Year 2 Monitoring Report

LITTLE SEBASTIAN SITE

NCDMS Project # 100027 (Contract # 7187) | RFP 16-006993 (Issued 9/16/2016)
USACE Action ID: SAW-2017-01507 | DWR Project # 2017-1041

RE: Little Sebastian Mitigation Site: Year 2 Monitoring Report (NCDMS Project ID #100027)

Figure 2

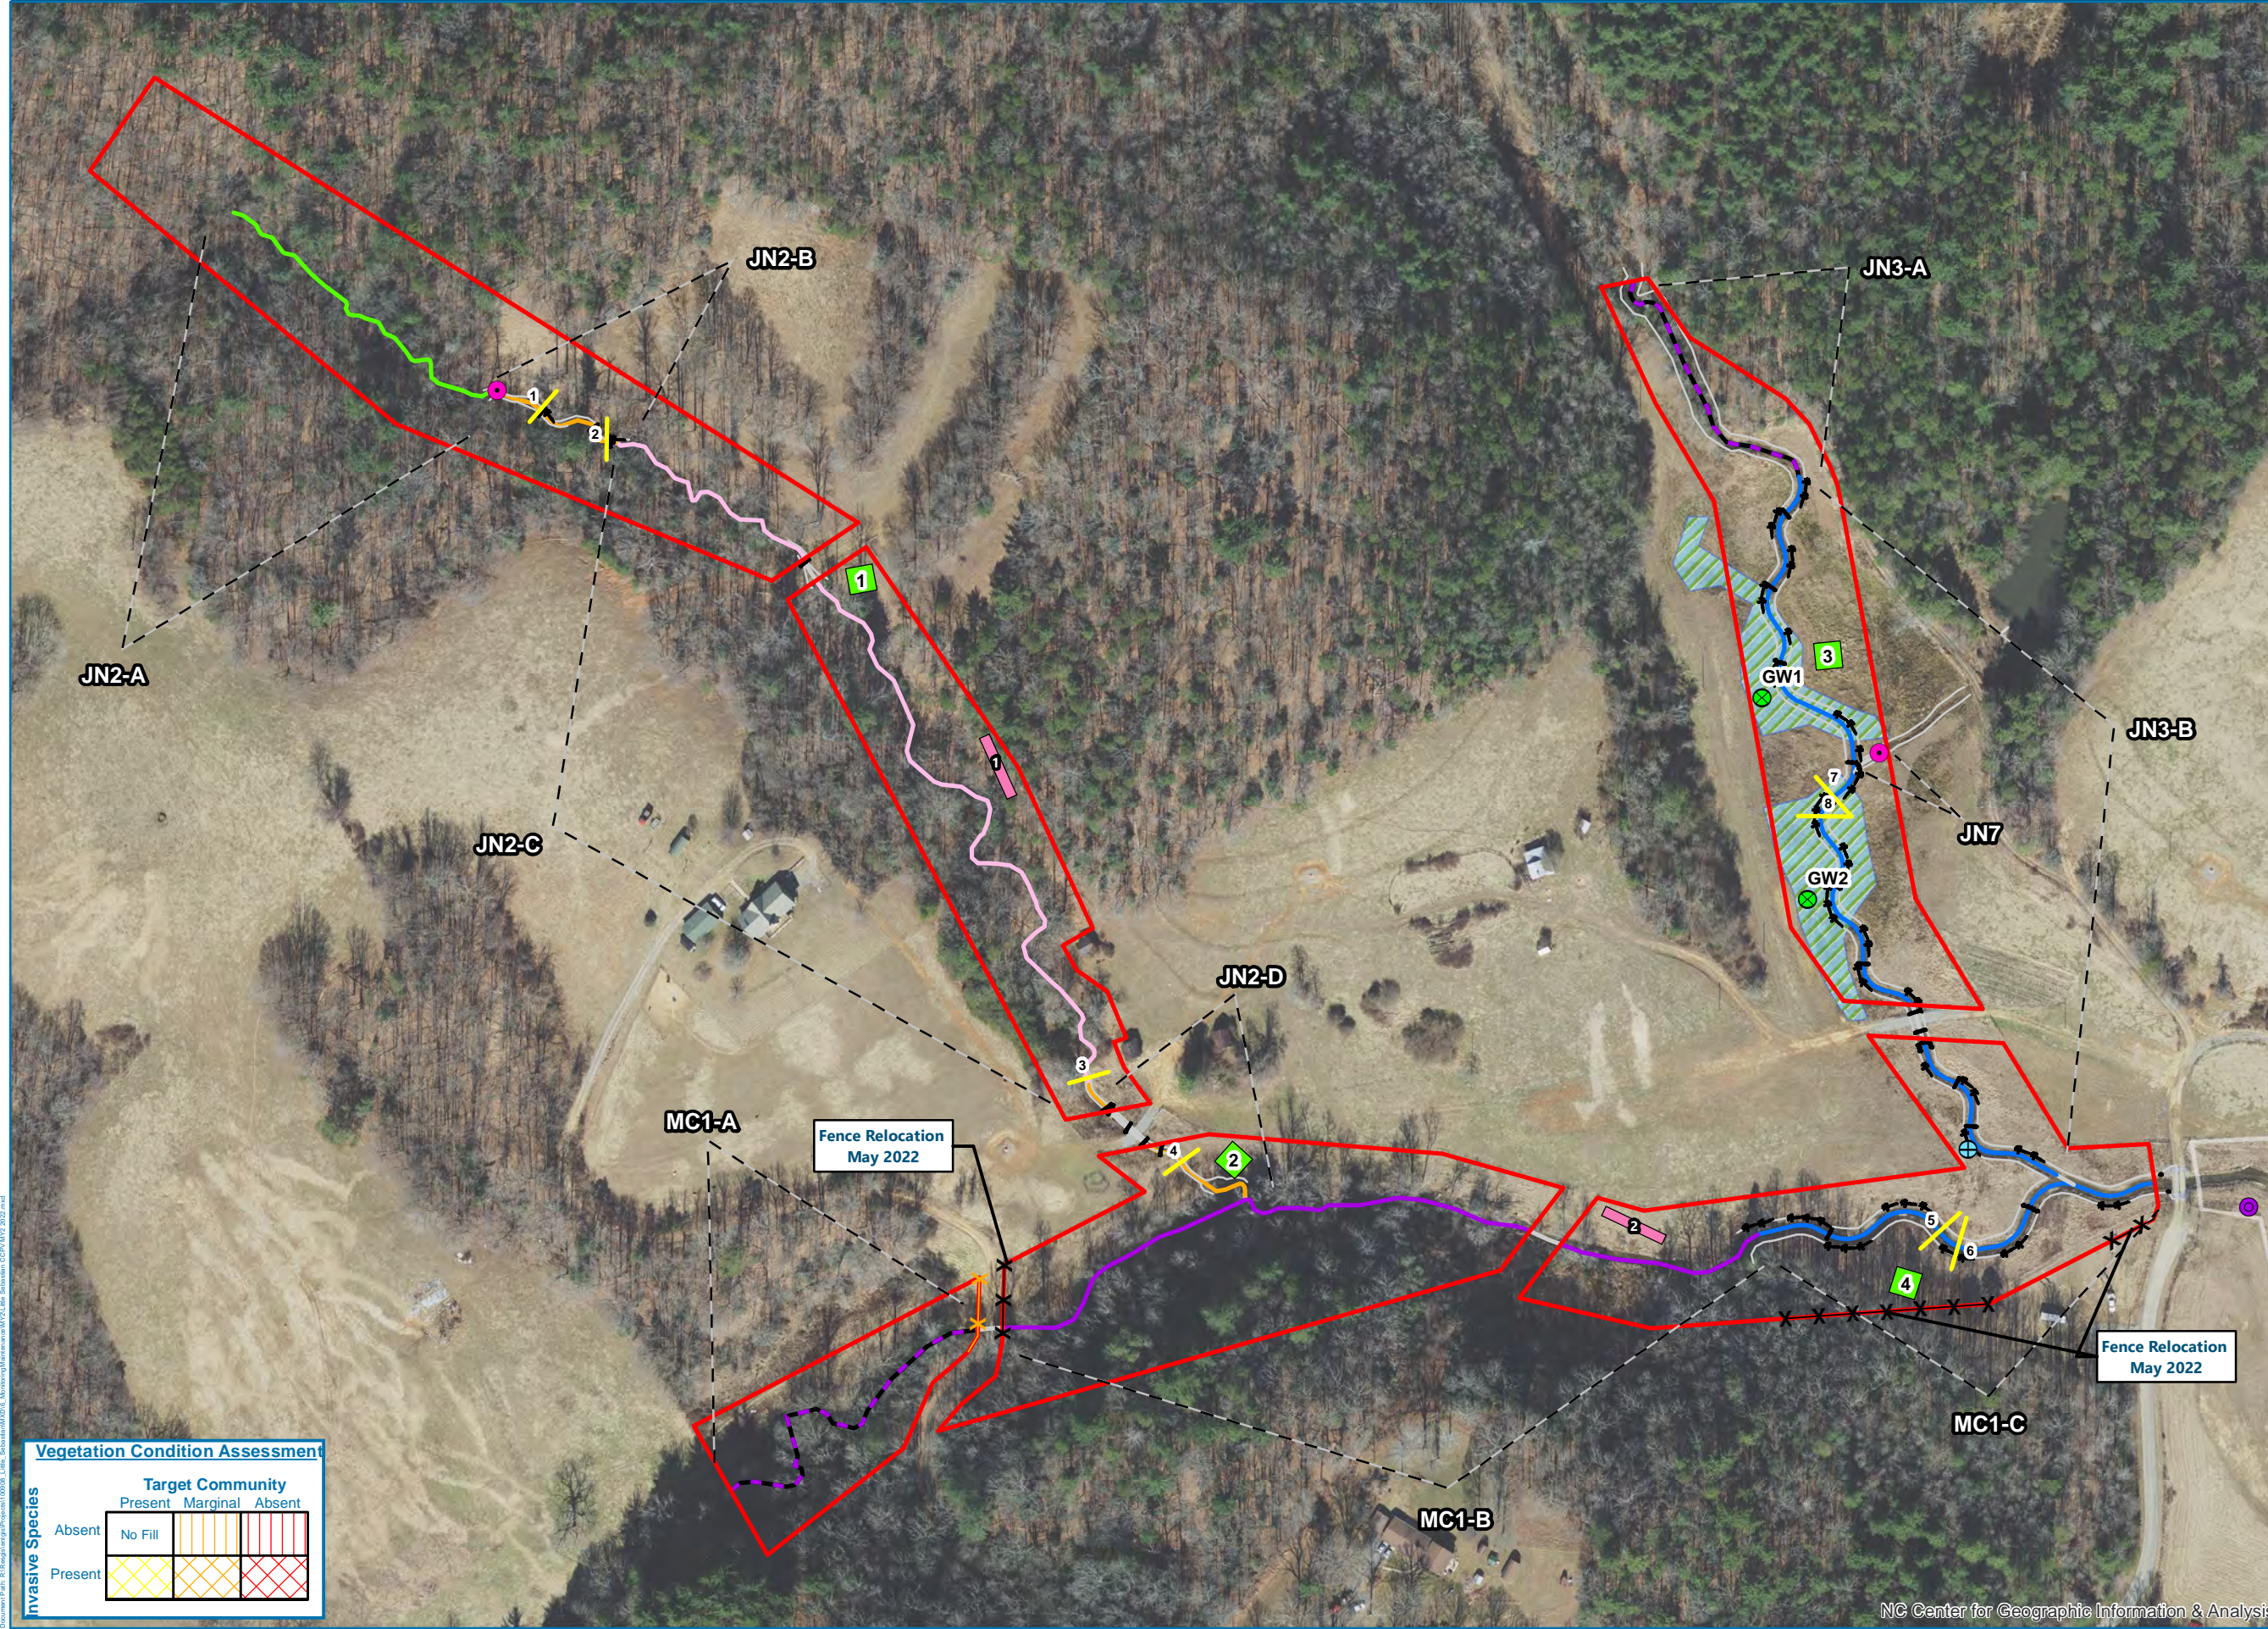
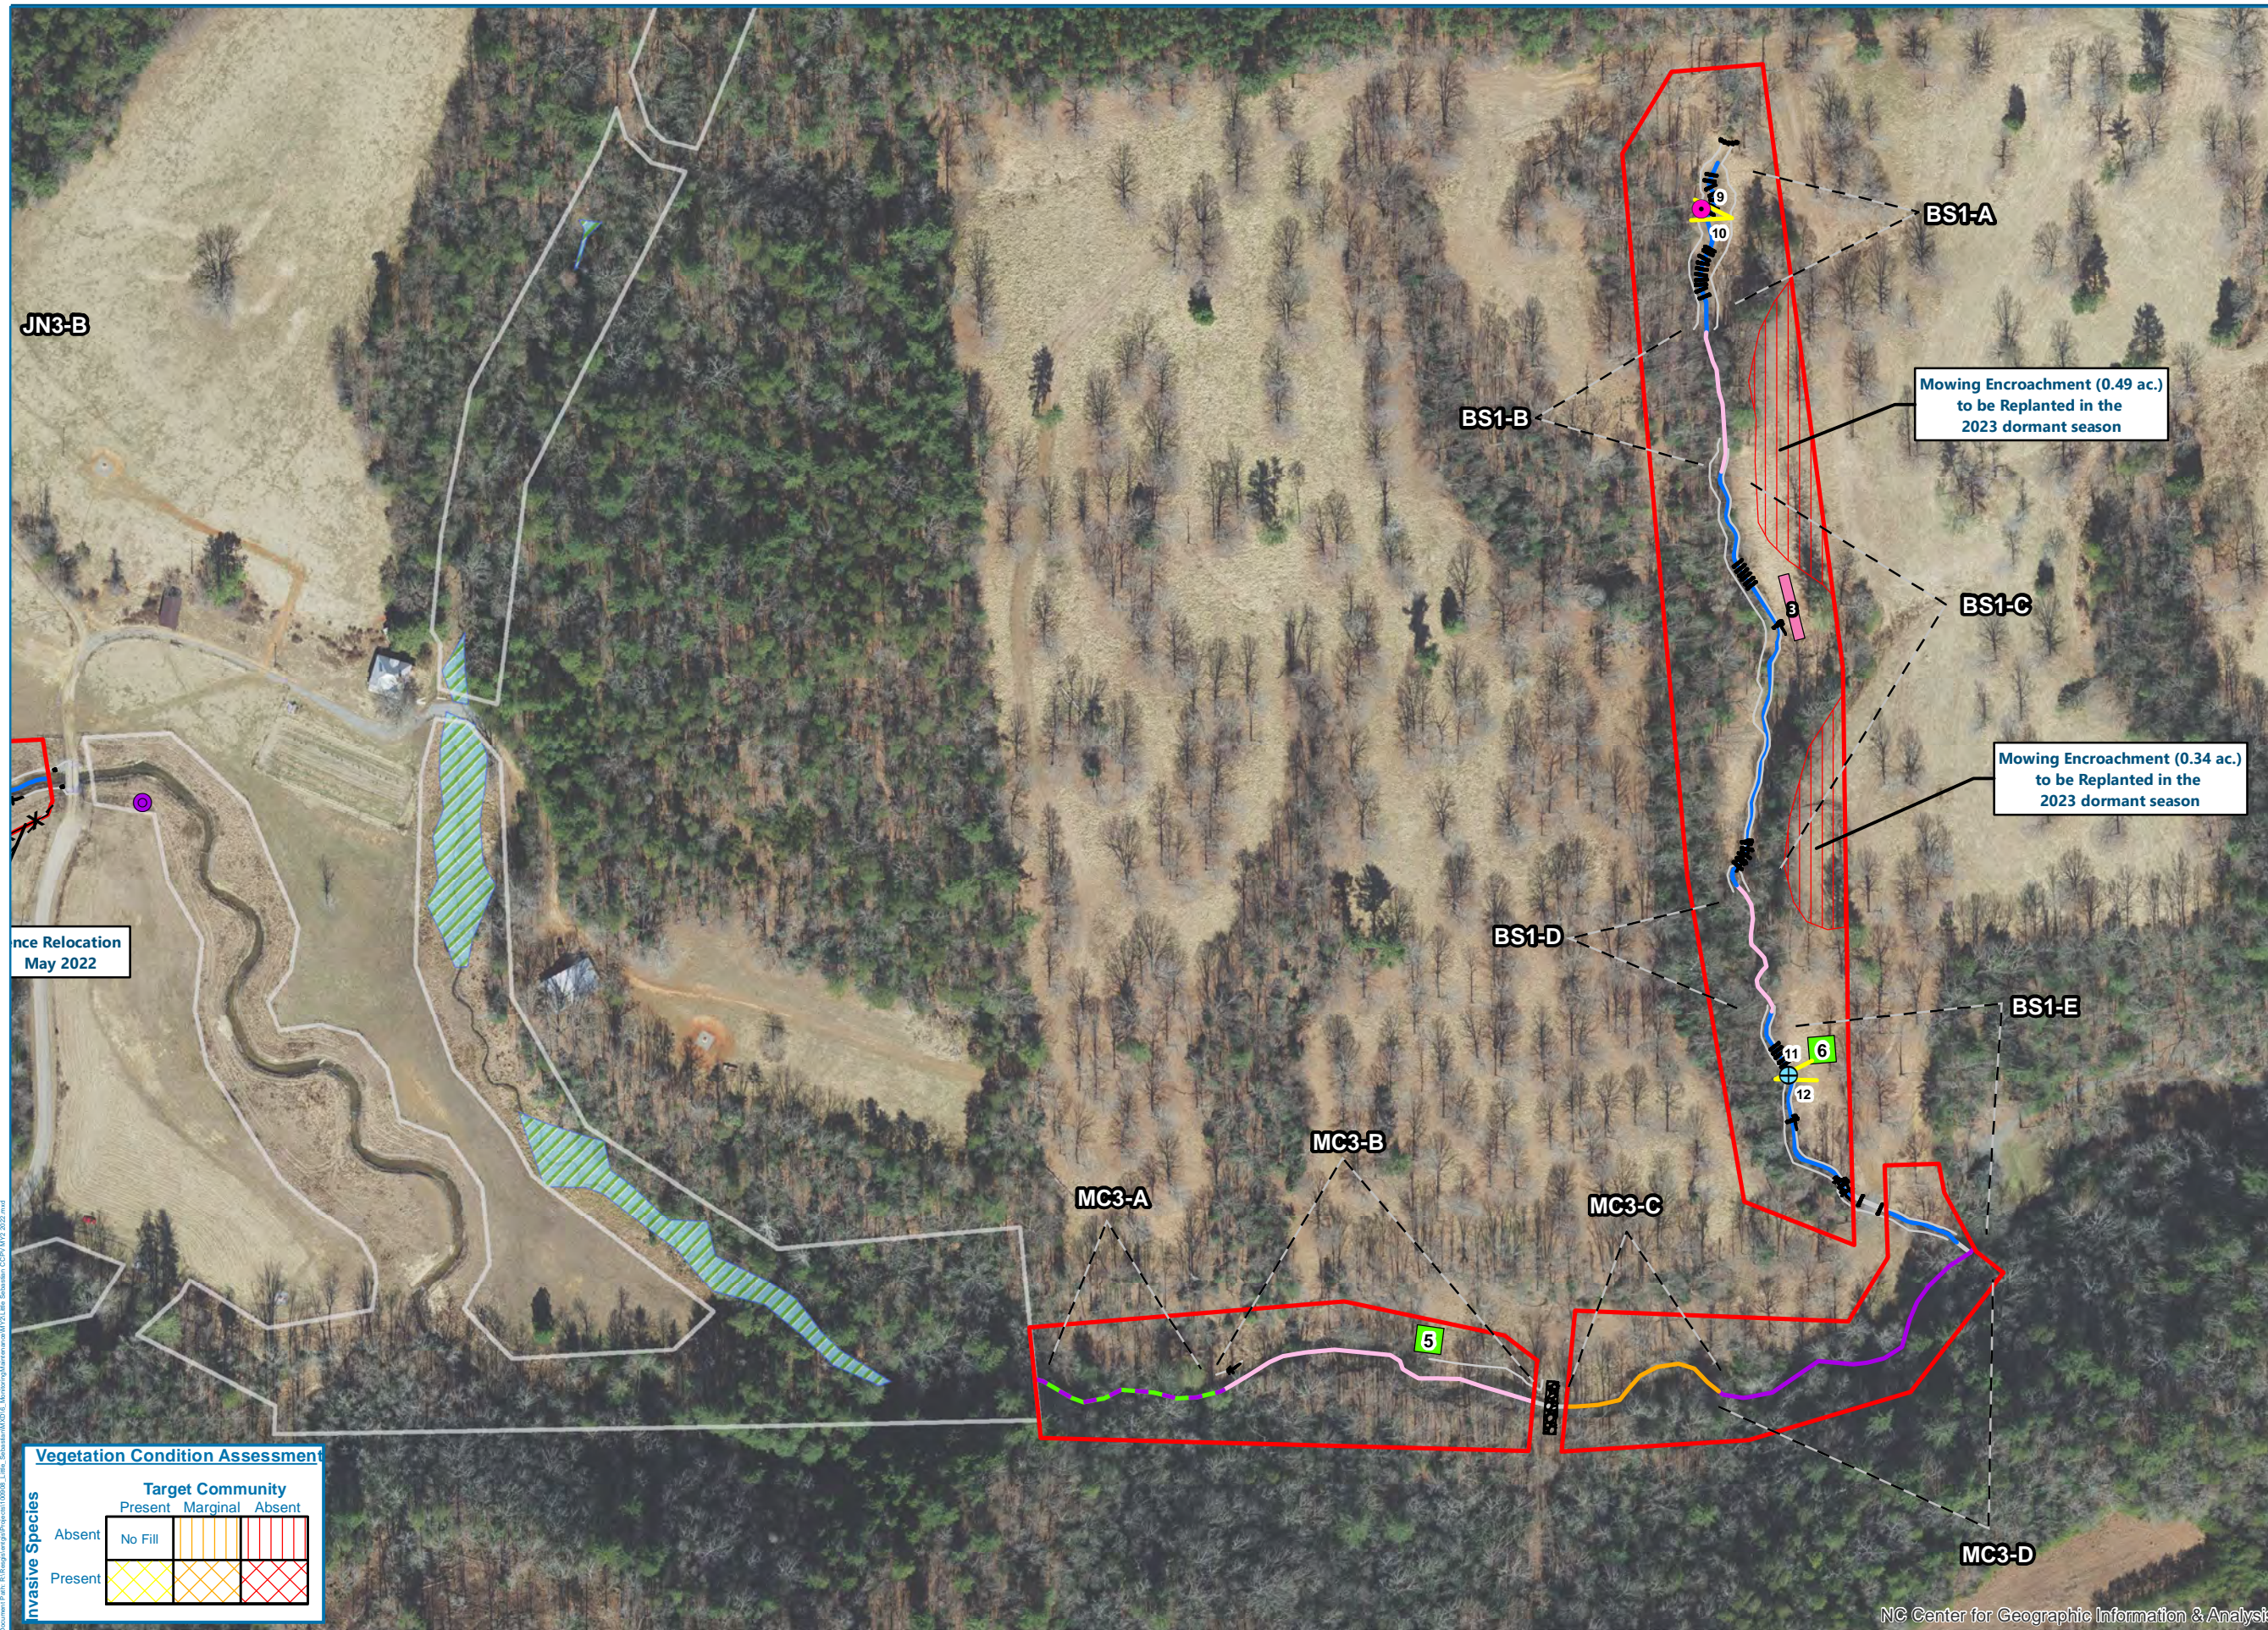
CCPV Maps – Figure 2: Please add a callout to the map to clearly define the MY2 (2022) encroachment areas reported. The callout/s should also indicate that these areas will be replanted in the 2022/ 2023 dormant season as specified in the report.

CCPV Maps – Figure 2: A steep stream bank was observed on MC3-B/ MC3-C near the crossing during the last DMS monitoring site visit (2021). Please confirm that the bank continues to remain stable.

These call outs have been added to the encroachment/low stem density areas in Figure 2.

This bank continues to remain stable.

Mowing Encroachment (0.49 ac.)
to be Replanted in the
2023 dormant season

Mowing Encroachment (0.34 ac.)
to be Replanted in the
2023 dormant season

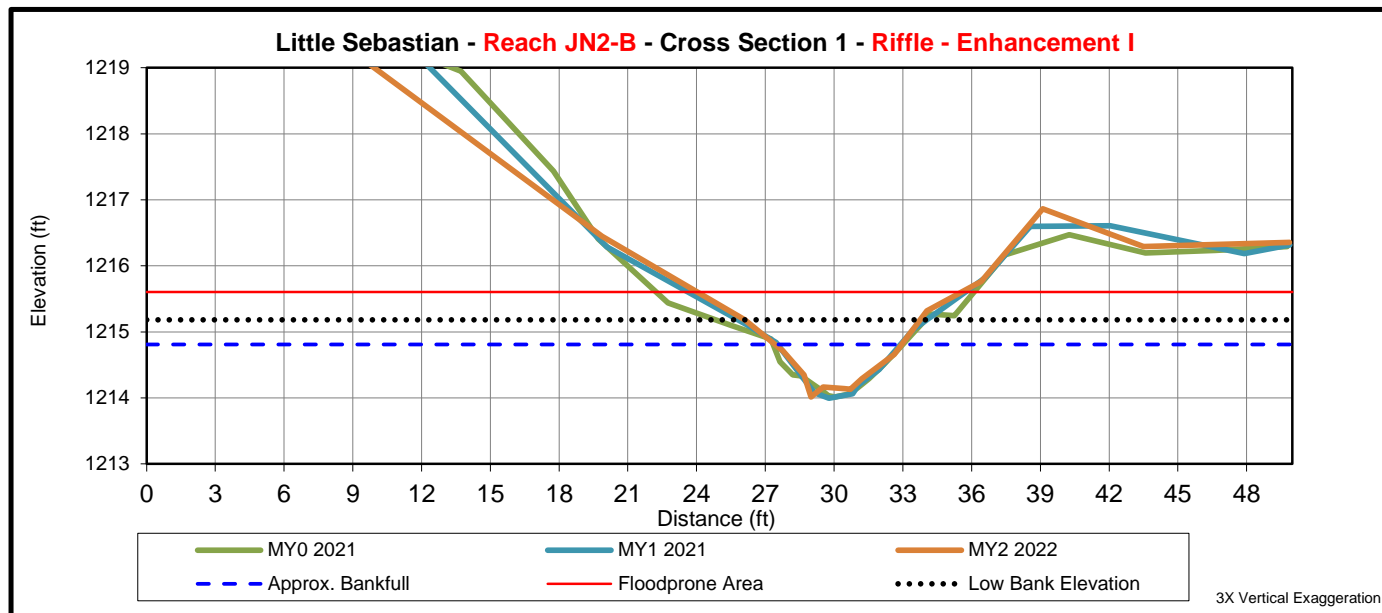
Appendix D – Cross Sections: Please review and QA/QC the cross-section data provided in Table 11 and the corresponding project cross-section graphs. Cross sections 1; 2; 3 and 11 show notable changes for Bankfull Bank Height Ratio between MY1 and MY2; however, these changes do not appear to be reflected in the cross-section graphs provided. Once reviewed, please discuss the individual cross-section Bankfull Bank Height Ratio changes in the revised report text.

Cross Section 1- because this is an Enhancement I section with steeper, uneven slopes, choosing the same location to call top of bank, year to year, is difficult; therefore, minor changes are expected in bank height ratios. Additionally, because the morphology tables are set to round numbers to one decimal place, the change from MY1 to MY2 may look more drastic than it is. MY1, cross section 1 had a bank height ratio of 1.380952381; MY2 cross section 1 had a bank height ratio of 1.467336683 (only 6% change). This is less than a 10% difference.
